UNITED STATES PATENT AND TRADEMARK OFFICE

APPLICATION NO.	FILING DATE	FIRST NAMED INVENTOR	ATTORNEY DOCKET NO.	CONFIRMATION NO.
10/798,140	03/11/2004	Domenic V. Apprille JR.	8127	5560

Office Action Summary	Application No. 10/798,140	Applicant(s) APPRILLE, DOMENIC V. C	
	Examiner Sean M. Michalski	Art Unit 3725

DETAILED ACTION

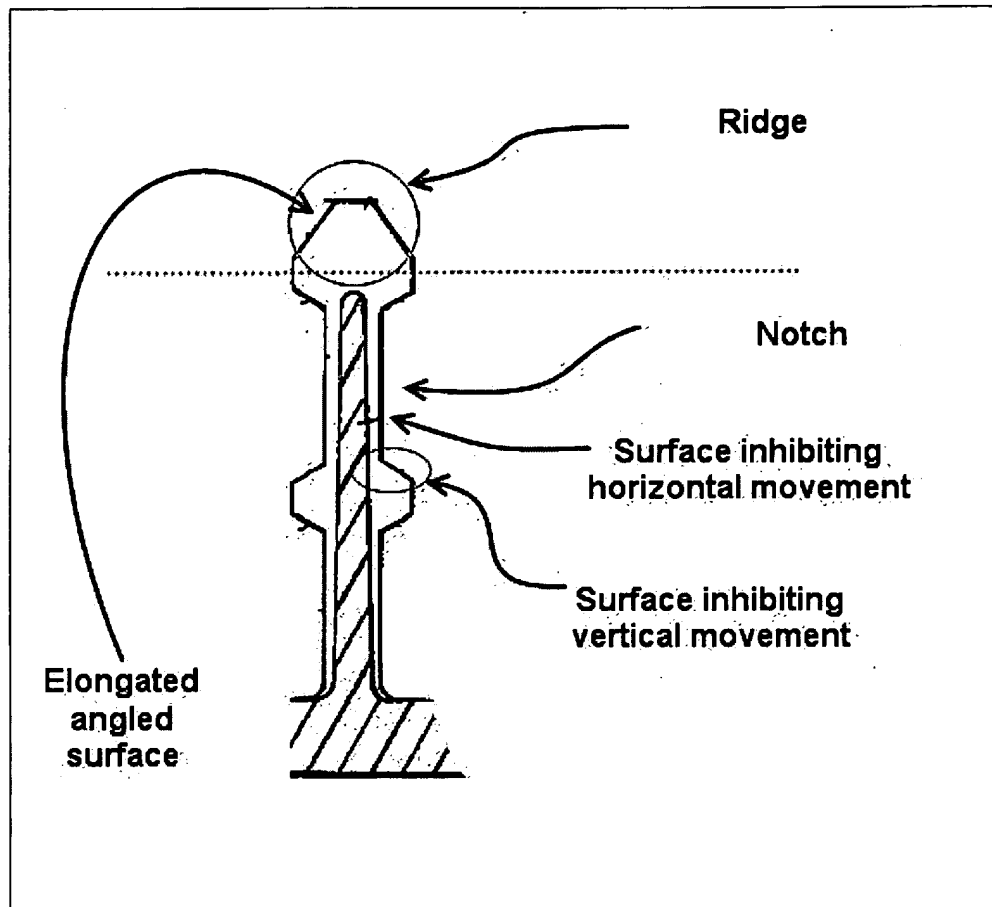
12. Regarding claim 8, Petrillo further discloses that the latch comprises an elongate ridge (see below)

13. Regarding claim 9, Petrillo further discloses a notch (see figure above).
14. Regarding claim 10, Petrillo further discloses surfaces to inhibit movement (see figure above).
15. Regarding claim 11, Petrillo further discloses an elongated angled surface configured to facilitate insertion of a blade unit into the respective section (column 3 line 4).
16. Regarding claims 18 and 48, Petrillo further discloses that the cartridge dividers further include blade unit dividers that extend perpendicularly from the base (200 figure 7) and define blade unit regions in which the blade units are received (see figure 7, the dividers demark the limits of a region within which the blade units 20 are received).

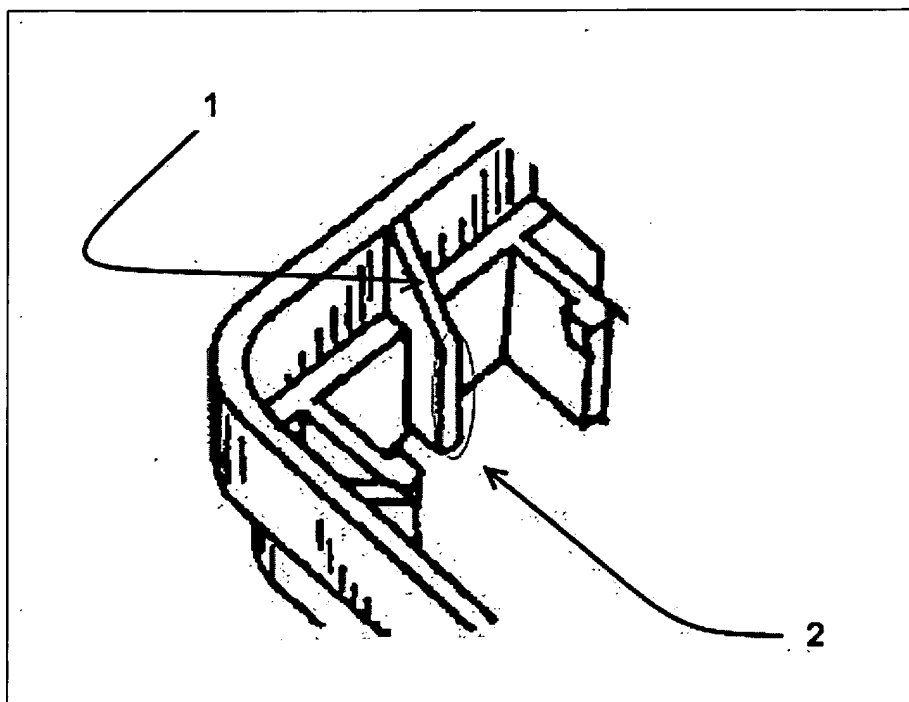
25. Regarding claims 10/4, 10/8, 15/5, 15/13, 40, 45 Kohring further discloses that the latches have two surfaces, seen below, labeled 1 and 2 for convenience.

Surface 1 is positioned to inhibit vertical movement of the protrusion on the blade unit, since it was designed to cam with that surface and prevent it from being located in the area below surface 1 (column 3 lines 35-40). Surface 2 is positioned to inhibit horizontal movement of the respective protrusion on the blade unit. When the blade unit C is in the housing, it's movement towards the latch is inhibited by the presence of the latch. The latch prevents the protrusion from moving horizontally out of the housing.

26. Regarding claim 16, 41, 46 Kohring further discloses that each ridge includes an elongated angled surface configured to facilitate insertion of a blade unit into the respective section. Surface 1 (in the figure above) was designed to cam with the blade unit (column 3 lines 35-40).

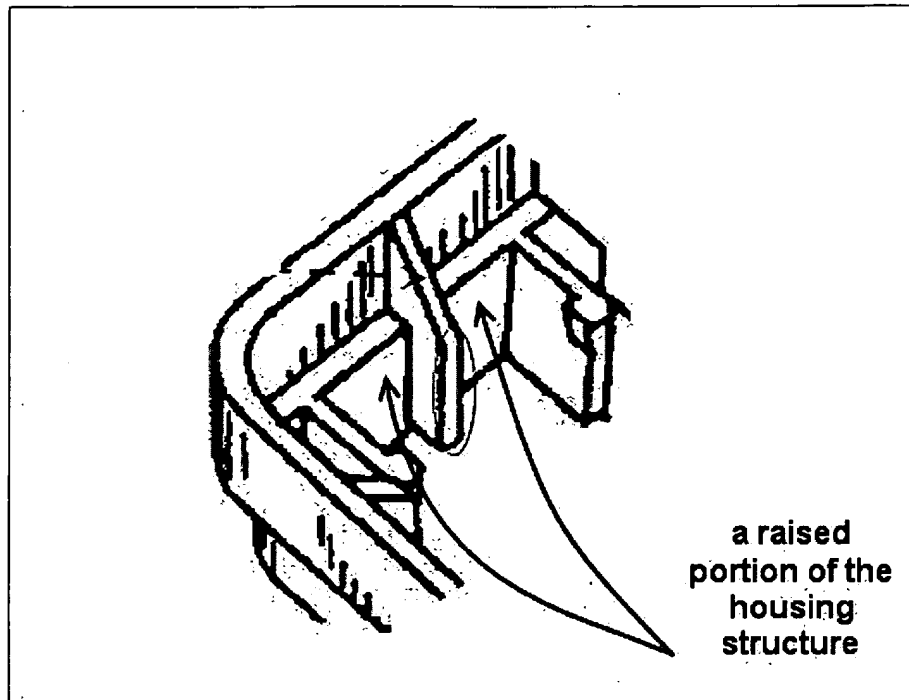
35. Regarding claims 29 and 30, Kohring does not disclose that the latching portion comprises an elastomer, but discloses the use of Plastic, which is in many ways similar to an elastomer.

In the same field of invention it would have been obvious to one skilled in the art at the time of the invention to modify Kohring by using an elastomer latch, since it has been held to be within the general skill of a worker in the art to select a known component or material on the basis of suitability for the intended use as a matter of obvious mechanical design expediency. *In re Leshin*, 125 USPQ 416. Also see MPEP 2144.07. *Sinclair & Carroll Co. v. Interchemical Corp.* states "Reading a list and selecting a known compound to meet known requirements is no more ingenious than selecting the last piece to put in the last opening in a jig-saw puzzle." 325 U.S. at 335, 65 USPQ at 301.). Since the properties of many materials (including elastomers) are well known, the designation of a specific material does nothing to enhance the patentability of a design.

If the latch portion were modified as above, there would still be a raised portion of the housing structure (seen below) which would underlie the elastomer latch.
